SEPTIC SYSTEM:

APPLICATION FOR INDIVIDUAL SEWAGE DISPOSAL SYSTEM PERMIT

SOILS PERCOLATION TEST DATA

Subject: Percolation Test for Cisco Lundsford - A.P.# 308-231-02

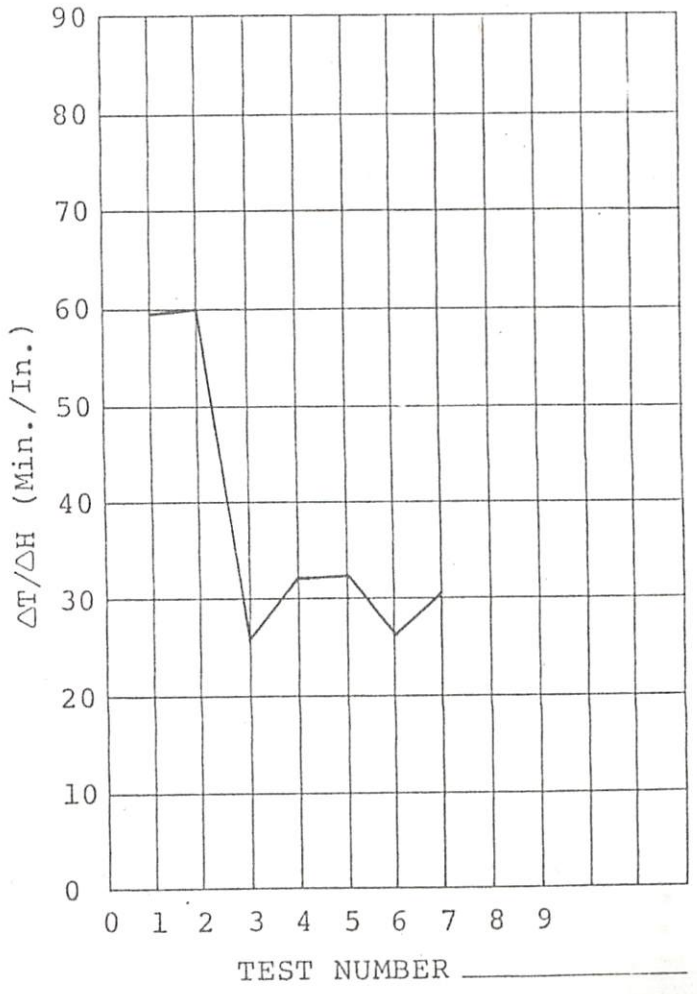
a meeting was held in my office
to review the percolation test results
submitted on this parcel - the
variations from our procedures ^{were}
discussed including hole size,
leaking test, measurement
method. Also reviewed the
skewed results on hole #4.
Reviewed profiles, texture
analysis and observed
sample of soil. Clark had
collected. Discussed type of
soil and location of
project. The conclusion
was that the percolation
tests were not properly
conducted and should
be repeated.

SOILS PERCOLATION TEST DATA

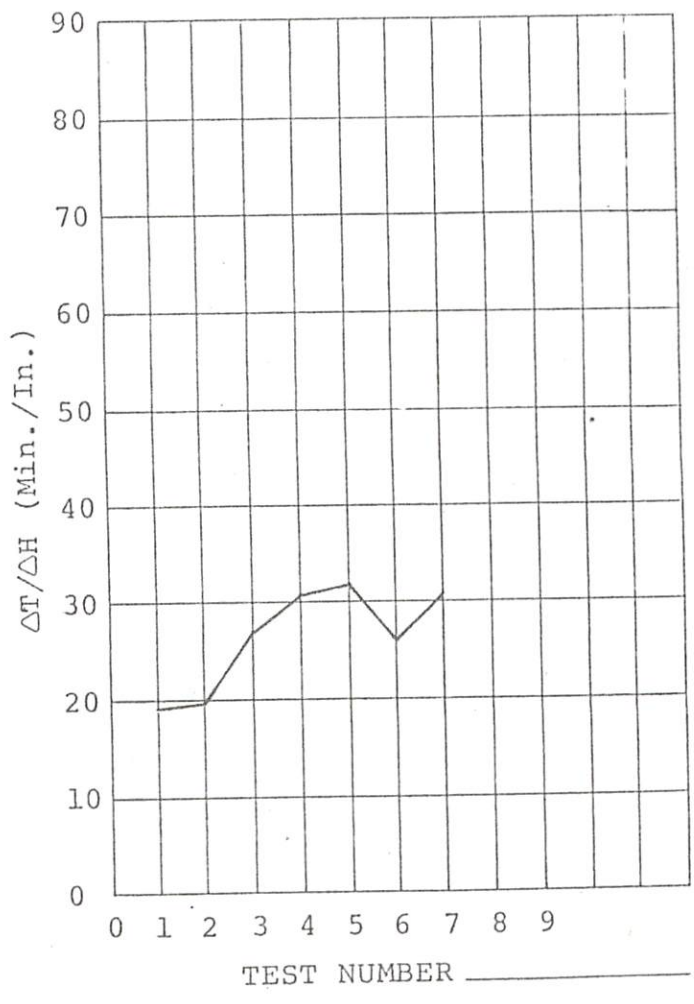
This is very interesting
why when 2' depth was
used per note dropped

I wonder how many holes
8" deep could influence note
Maybe 1/2" was better when
air soil interface was near
testing level

1st test not stable

EXPLORATION HOLE LOG

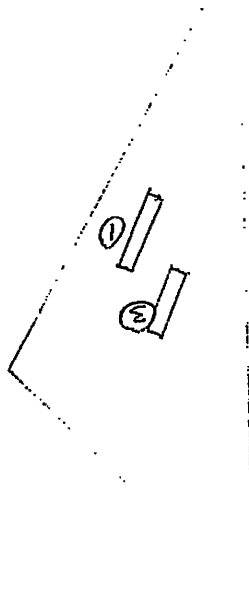
3' water unless water unusable

assume water table a sat. soil
